Subject: FUEL DENSIFICATION

ORDER FOR MODIFICATION OF LICENSE

CHANGE NO. 16 TO THE TECHNICAL SPECIFICATIONS

SAFETY EVALUATION OF THE
FUEL DENSIFICATION EFFECTS ON THE
OYSTER CREEK NUCLEAR GENERATING STATION

Figure 3.10.1

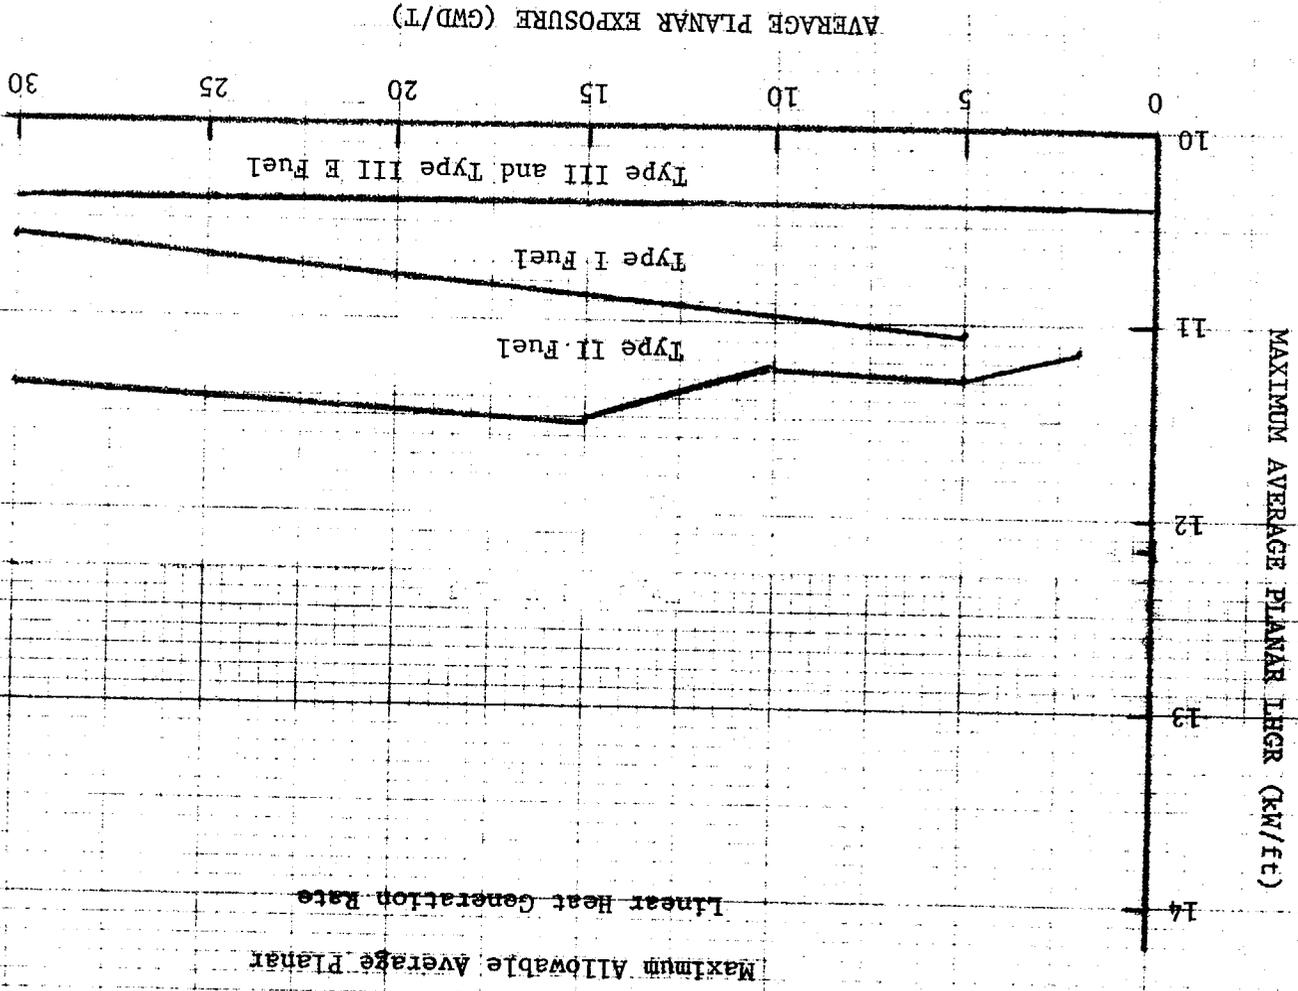
During steady state power operation, the average linear heat generation rate (LHGR) of all the rods in any fuel assembly, as a function of average planar exposure, at any axial location shall not exceed the maximum average planar LHGR shown in Figure 3.10.1.

The maximum average planar LHGR shown in Figure 3.10.1 for Type I and Type II fuel are the same as that shown on the curves labeled " γ " (Gamma) on Figure 4-9A1 and 4-9A2 of the GE topical report "Fuel Densification Effects on General Electric Boiling Water Reactor Fuel," NEDM-10735, Supplement 6, August 1973 and are the result of the calculations presented in Section 4.3.4 of the same report. These calculations were made to determine the effect of densification on peak clad temperature and were performed in accordance with the AEC Fuel Densification Model for BWRs which is attached to NEDM-10735, Supplement 6 as Appendix B.

The maximum average planar LHGR shown in Figure 3.10.1 for Type III and Type III E fuel represents the result of the staff's independent analysis of the response of Exxon Nuclear Company's fuels under loss-of-coolant accident conditions. For this analysis, the staff has applied a 100°F allowance to account for difference in geometry between the Exxon fuel assembly and the fuel assembly for which spray cooling heat transfer data were obtained.
